**UN Regulations Nos. 13, 13-H, 139, 140 and UN GTR No. 8:
Clarifications**

Proposal for a supplement to the 11, 12 and 13 series of amendments to UN Regulation No. 13 (Heavy Vehicle Braking)

Submitted by the expert from the United Kingdom of Great Britain and Northern Ireland*

Paragraph 5.1.2.4.3.1., amend to read:

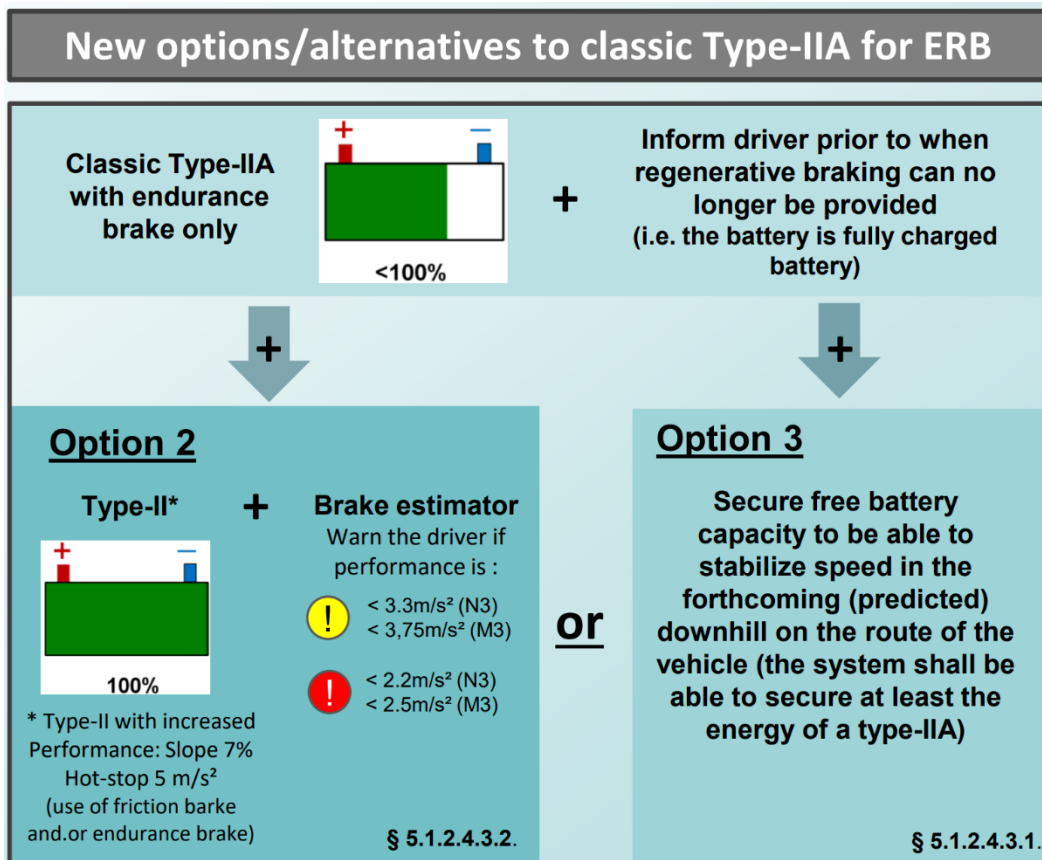
“5.1.2.4.3.1. It shall be deemed to comply with the requirements in paragraphs 5.1.2.4.1. and 5.1.2.4.2., if the vehicle equipped with the endurance braking system is able to store and/or dissipate (e.g. with an extra-endurance brake) the energy of the maximum negative vertical height difference (requiring energy storage capacity in the traction battery), limited to the energy level as required to fulfil the requirements in paragraphs 5.1.2.4.1. and 5.1.2.4.2., that can be reached by the vehicle (consuming stored energy in the traction battery on the journey towards the relevant negative vertical height difference), considering the current electric state of charge, using methods such as a global navigation satellite systems combined with a topography model and an intelligent battery management system.

This shall be demonstrated to the satisfaction of the Technical Service, including through the test specified in Annex 4, paragraph 1.8.2.5. (a) and submission of detailed documentation explaining the strategies implemented in the system and how this ensures endurance braking requirements can always be met.”
